Access Compliance Report

Public Rights-of-Way

Intersection ID: 13959	Main Street: CLEVELAND_AV	Cross Street: E_PARK_AV	Location: N
ADA ID: 14A304464CC7	Ramp Type: Perp	Initial Pass/Fail: Pass	Overall Compliance: No
			Severity Score: 20.25

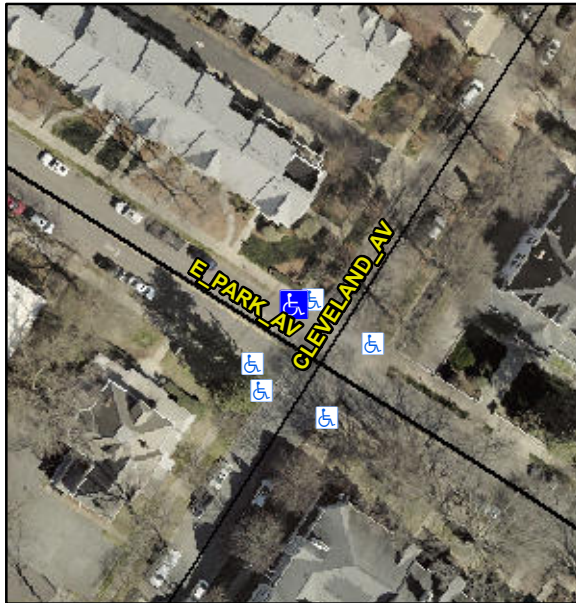
Not Found, R304.5.3, R304.2.3, R305.2, R302.7.2

Compliance	Description	Data	Compliance	Description	Data
N/A	Ramp Length (in)	36.0	Yes	Ramp Slope (%)	6.0
Yes	Ramp Width (in)	48.0	No	Ramp XSlope (%)	4.5
N/A	Flare Type LT	Sloped	N/A	Flare Type RT	N/A
N/A	Flare Slope LT (%)	15.3	Yes	Flare Slope RT (%)	7.6
N/A	Flare Traversable LT?	Yes	N/A	Flare Traversable RT?	Yes
Yes	Landing Length (in)	48.0	Yes	DWS Provided?	Yes
Yes	Landing Width (in)	48.0	Yes	DWS Contrast?	Yes
Yes	Landing Slope (%)	0.6	Yes	DWS Length (in)	24.0
No	Landing X Slope (%)	2.1	Yes	DWS Full Width?	Yes
N/A	Landing Curb? (Y/N)	No	No	DWS Offset (in)	4.5
N/A	Shared Landing?	Yes			
Yes	Gutter Ponding?	No	Yes	Gutter Slope (%)	3.9
No	Gutter Lip Ht (in)	1.0	Yes	Gutter X Slope (%)	1.5
N/A	Painted X Walk1?	No	N/A	Painted X Walk2?	N/A
	X Walk 1 Direction	To SW		X Walk 2 Direction	N/A
N/A	X Walk 1 Width (in)	N/A	N/A	X Walk 2 Width (in)	N/A
	X Walk 1 Slope (%)	6.4		X Walk 2 Slope (%)	N/A
	X Walk 1 X Slope (%)	1.2		X Walk 2 X Slope (%)	N/A

Remove & Replace Entire Ramp.
